Report to
Rapport au:

Ward: RIDEAU-VANIER (12) File Number: ACS2020-PIE-PS-0004

SUBJECT: Zoning By-law Amendment – 116 York Street

1. That Planning Committee recommend Council refuse an amendment to Zoning By-law 2008-250 for 116 York Street to permit a 17-storey hotel, as detailed in Document 2.
2. That Planning Committee approve the Consultation Details Section of this report be included as part of the 'brief explanation' in the Summary of Written and Oral Public Submissions, to be prepared by the Office of the

Figure 1: Excerpt of Schedule 74 showing maximum building heights.

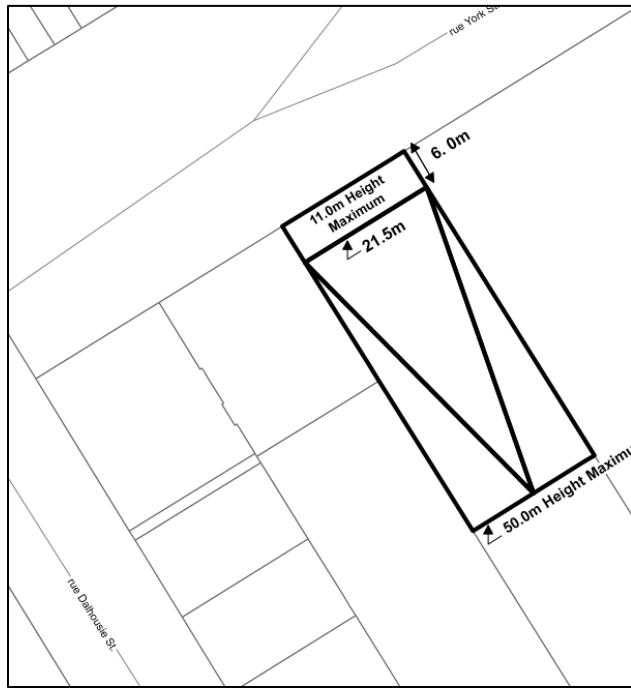
The BMHCD Study recommends only low-rise development as a means of protecting and maintaining the heritage value and character of the district, which is largely characterized by small scale individual buildings. While Heritage Ottawa accepts relief from the Heritage Overlay provisions, we oppose relief from the height and angular plane provisions of the Zoning By-law. As noted in the Planning Rationale prepared for the proponent, the angular plane is intended to achieve built form objectives, which includes protecting and prioritizing the predominant low-scale form that characterizes the Byward Market HCD. The proponent argues that the angular plane makes “prohibitively small” floor areas above the 10th floor. However, the solution is not to permit additional height. Rather, creative solutions to stepping back the building will be required as the height approaches the maximum allowable height of 50.0 metres.

Moreover, the transition from low-rise podium to high-rise tower is not successful. Accepting that the south elevation of the tower will attain a height of 50.0 metres, in no circumstance should the tower portion rise as a singular extruded mass. Articulation and progressive stepping back is required to provide visual relief and to minimize the effect of height. Relief from the angular plane provision should therefore not be granted.

Document 2 (a) – Proposed Development: York Street Elevation

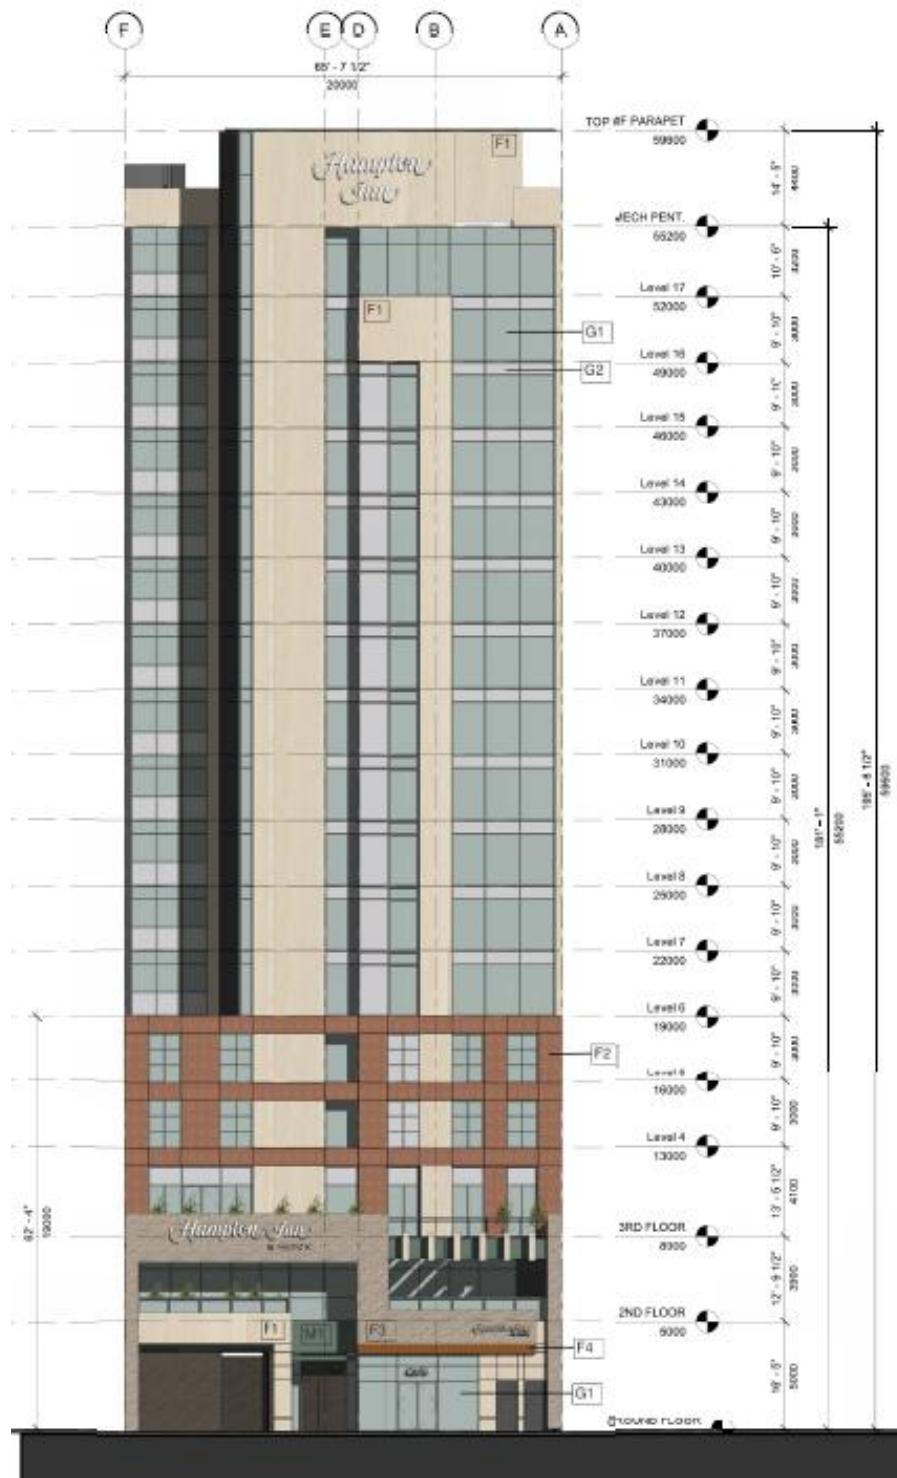
Elsewhere, the massing and height of the podium are acceptable, and consistent with the BMHCD guidelines. It is acknowledged that the proposed treatment and massing of the podium attempts to establish a relationship with the adjacent S.J. Major Building and other lower-scale development.

Document 3 – Proposed Ground Floor Plan

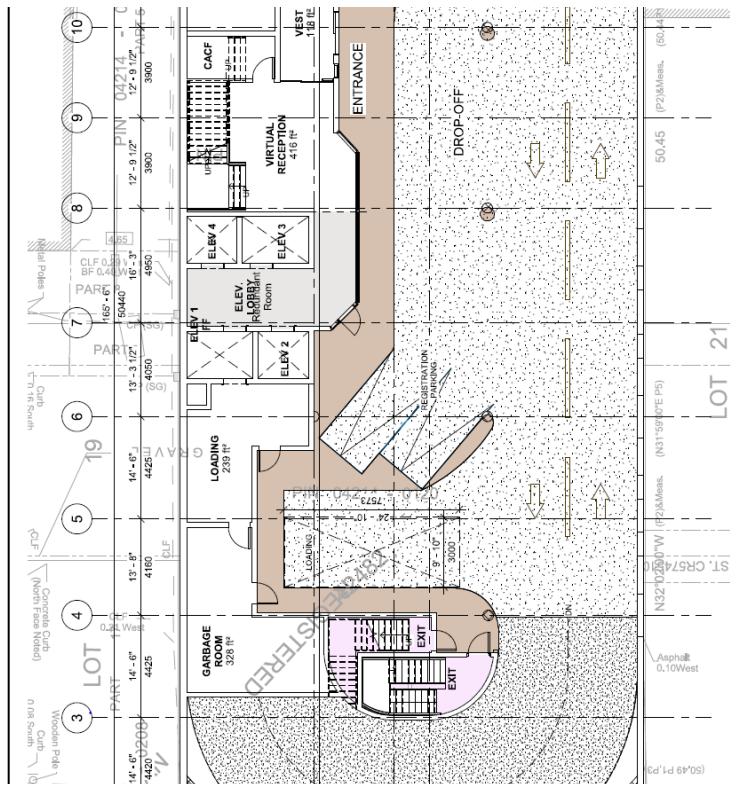
Response:

Staff are concerned with the location of the proposed loading space. Staff would prefer that the owner coordinate with adjacent property owners to share loading facilities and eliminate the driveway along York Street.
